DEVELOPMENT REVIEW BOARD REPORT

Axis/Radius remodel and expansion

55-DR-2012

Request: Request approval of the site plan, building elevations, and landscape plan for the remodel and expansion of an existing commercial building.

Development Review
 Site Plan
 PROJECT # 12008
 2ND REVIEW 2012.04.05
 3RD REVIEW 2012.05.08

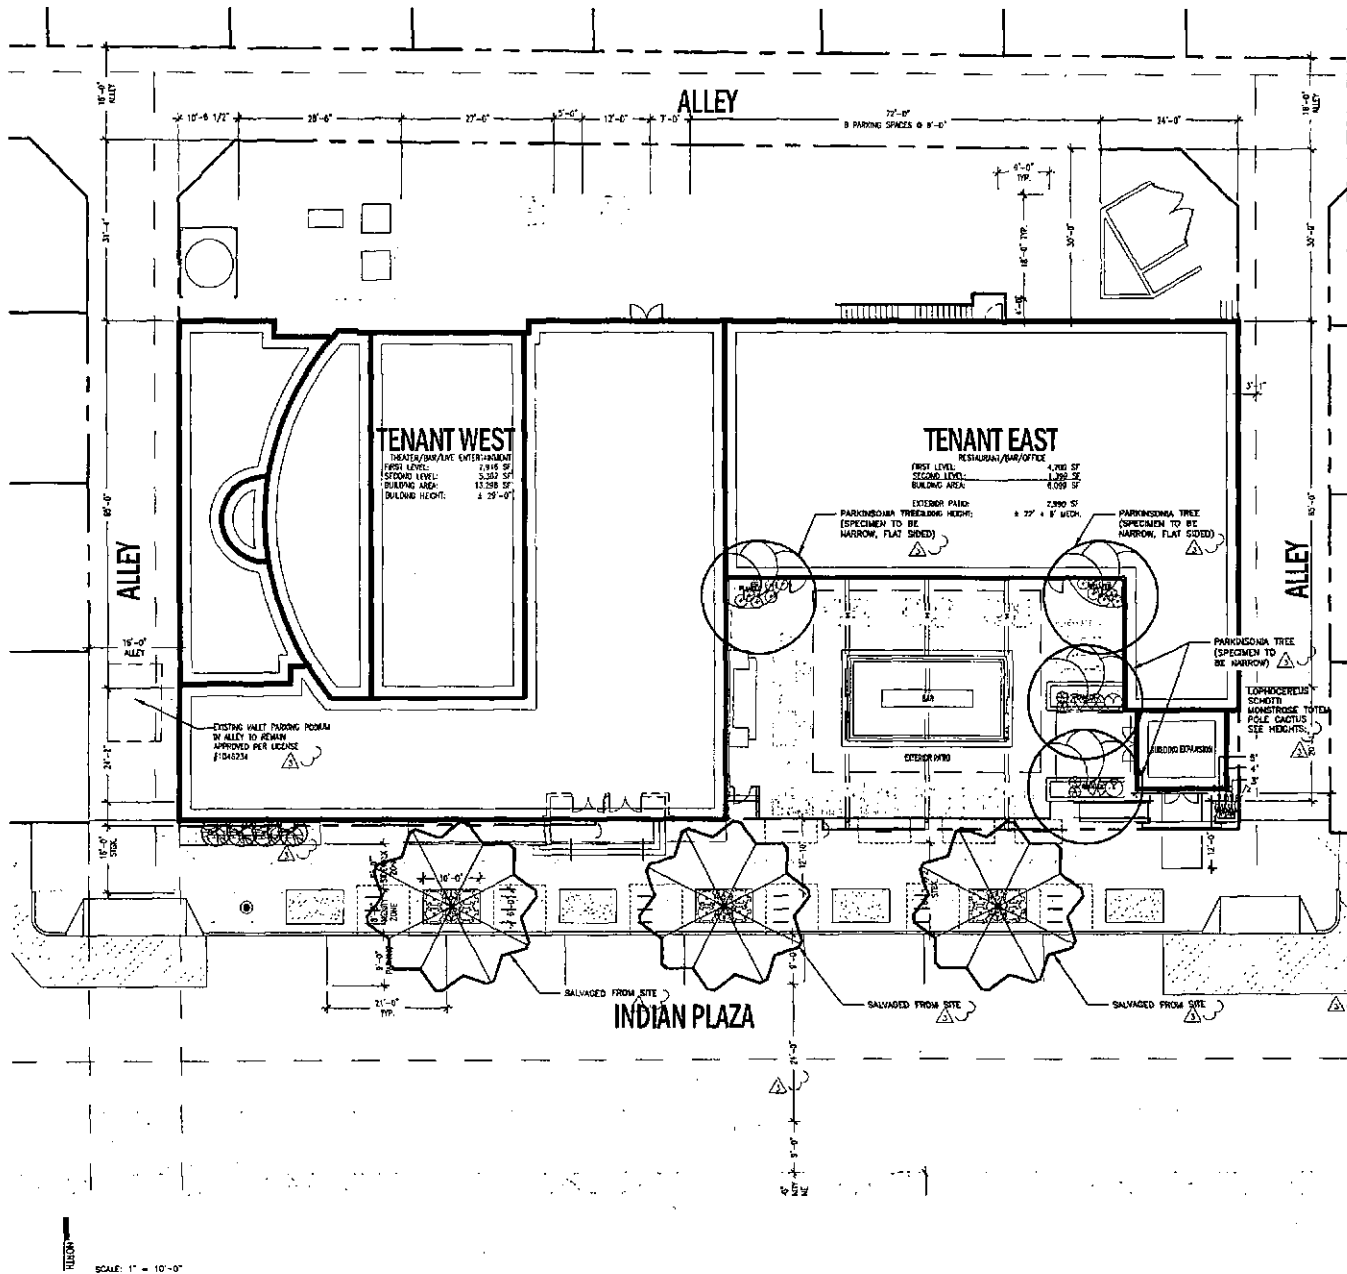
8. Improve the sidewalk along the Indian Plaza frontage to min. 8 foot width.
 - a. Proposed sidewalk is 10' and narrows to 8' clear next to proposed tree wells. – Kim 12-12-12. Per Phil's response email of 12-20-12, this is acceptable – **ADDRESSED** – Kim 12-21-12
9. If they plan to use valet service (which they do currently), **they need to identify a location on their site for this activity.** Using City right-of-way, alleys, public parking is not encouraged/supported and is only a last resort when there are no other alternatives. **OK per Walt; applicant uses side and rear alleys, not Indian Plaza. Provide a plan that identifies proposed valet operation station locations for the site buildings with DRB submittal.**
- 10.

11. ~~Provide more detail regarding the proposed planters that extend into the Indian Plaza parking spaces. **These have been removed.**~~
12. Why is the streetlight near the southeast corner of the site being removed/relocated? **Coordinate relocation with Todd Taylor in Transportation.**
13. Appears that a lot tie is in order.
14. **Identify existing alley right-of-way widths on the site plan.**
15. **Use less striping than shown on site plan for no parking areas in front of alley driveways.**

102. On the Development Review Site Plan, at the ends of the row of on-street parking spaces, there are pavement areas which are indicated with angle-striped-pattern that denotes a 'no parking' area. Please revise the site plan so that these 'no parking' areas will be converted in to landscape areas which will contribute to the Pedestrian Place concept that is described in the Downtown Character Area Plan. Steve V. 12/31/12 **04/12/13** (Per Steve & Kim 4-29 meeting, need to shift parking spaces so that a half-space isn't left at the end, and convert leftover space to landscape planters next to west alley and next to east alley. – Kim 4-30-13) **ADDRESSED 05/14/13**

Development Review
 West Bldg. Solar exhibit
 PROJECT # 12007
 SUP FILE# 2013 05 05

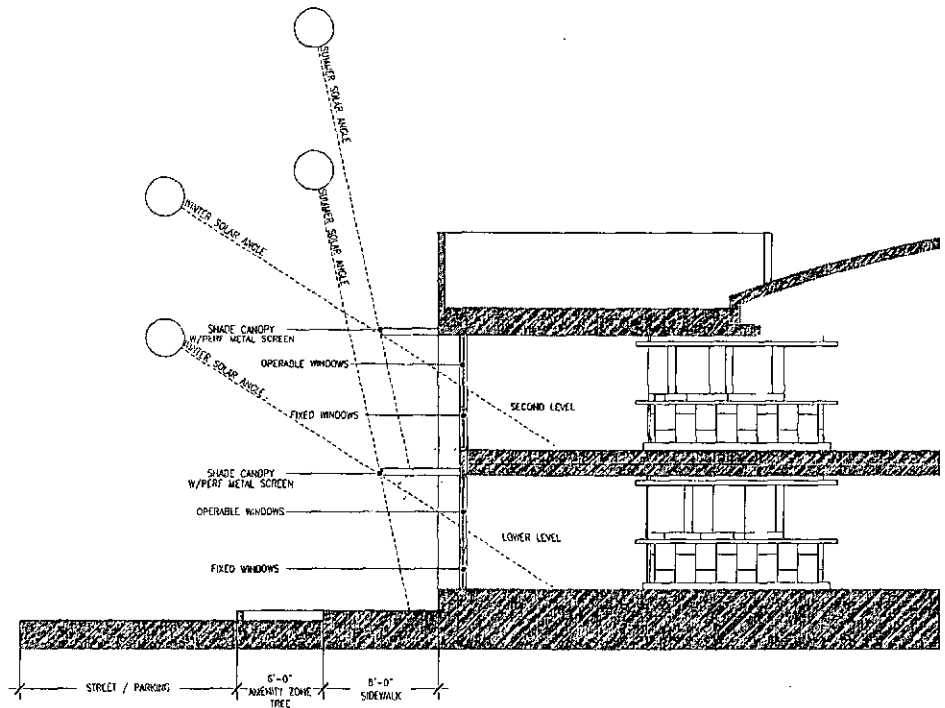
- b. Shade canopies for Tenant West building shall be constructed to be consistent with the West Bldg. Solar exhibit submitted by AV3 Design Studio with a city staff date of 5-28-13. Shade canopies for Tenant West building shall have shade material has a density of 75% or greater in order to maximize the effectiveness, and shall extend the entire length of all windows along the south elevation.

TYP. SIDEWALK HARDSCAPE SECTION
 SCALE: 1/8" = 1'-0"

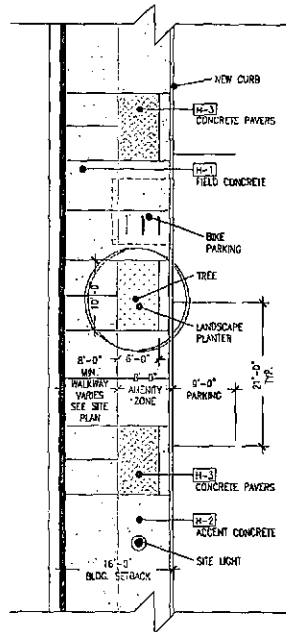
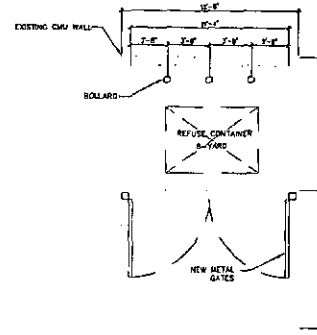
- e. Sidewalk and patio hardscape improvements and refuse gate shall be installed to be consistent with the Hardscape exhibit submitted by AV3 Design Studio with a city staff date of 5-8-13 and the color/material board entitled "Colors and Materials hardscape" submitted by AV3 Design Studio with a city staff date of 5-8-13.
